Appl. No. 10/848,747
Amdt. dated Oct. 29, 2004
Reply to office action of July 30, 2004

Amendments to the Drawings:

The attached sheet of drawings includes changes to FIGS. 1 and 4. This sheet, which includes Figs. 1, 2, and 4, replaces the original sheet including Figs 1, 2, and 4.

FIG. 1

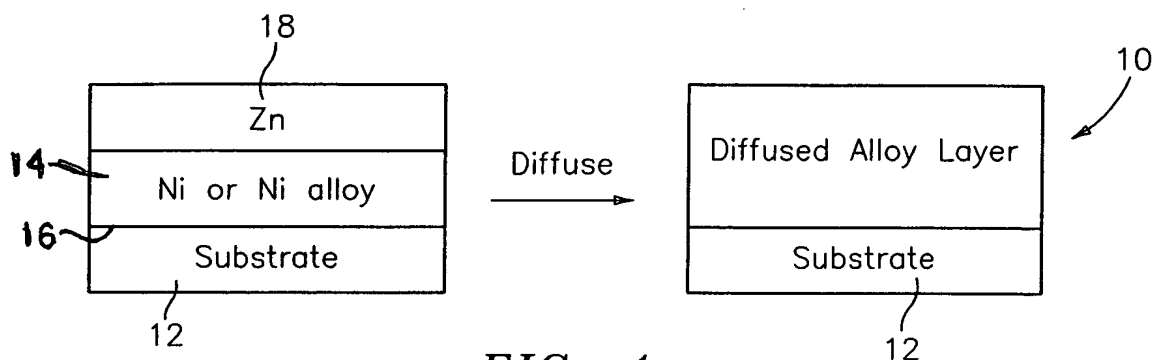
In the office action mailed July 30, 2004, the Examiner raised several objections to the drawings. With respect to FIG. 4, Applicants had previously presented a drawing correction with the Preliminary Amendment which was filed in this case. Not knowing whether this Amendment has gone astray, Applicants enclose herein a replacement sheet of drawings containing corrections to both FIGS. 1 and 4. The Examiner is hereby requested to approve the drawing corrections.
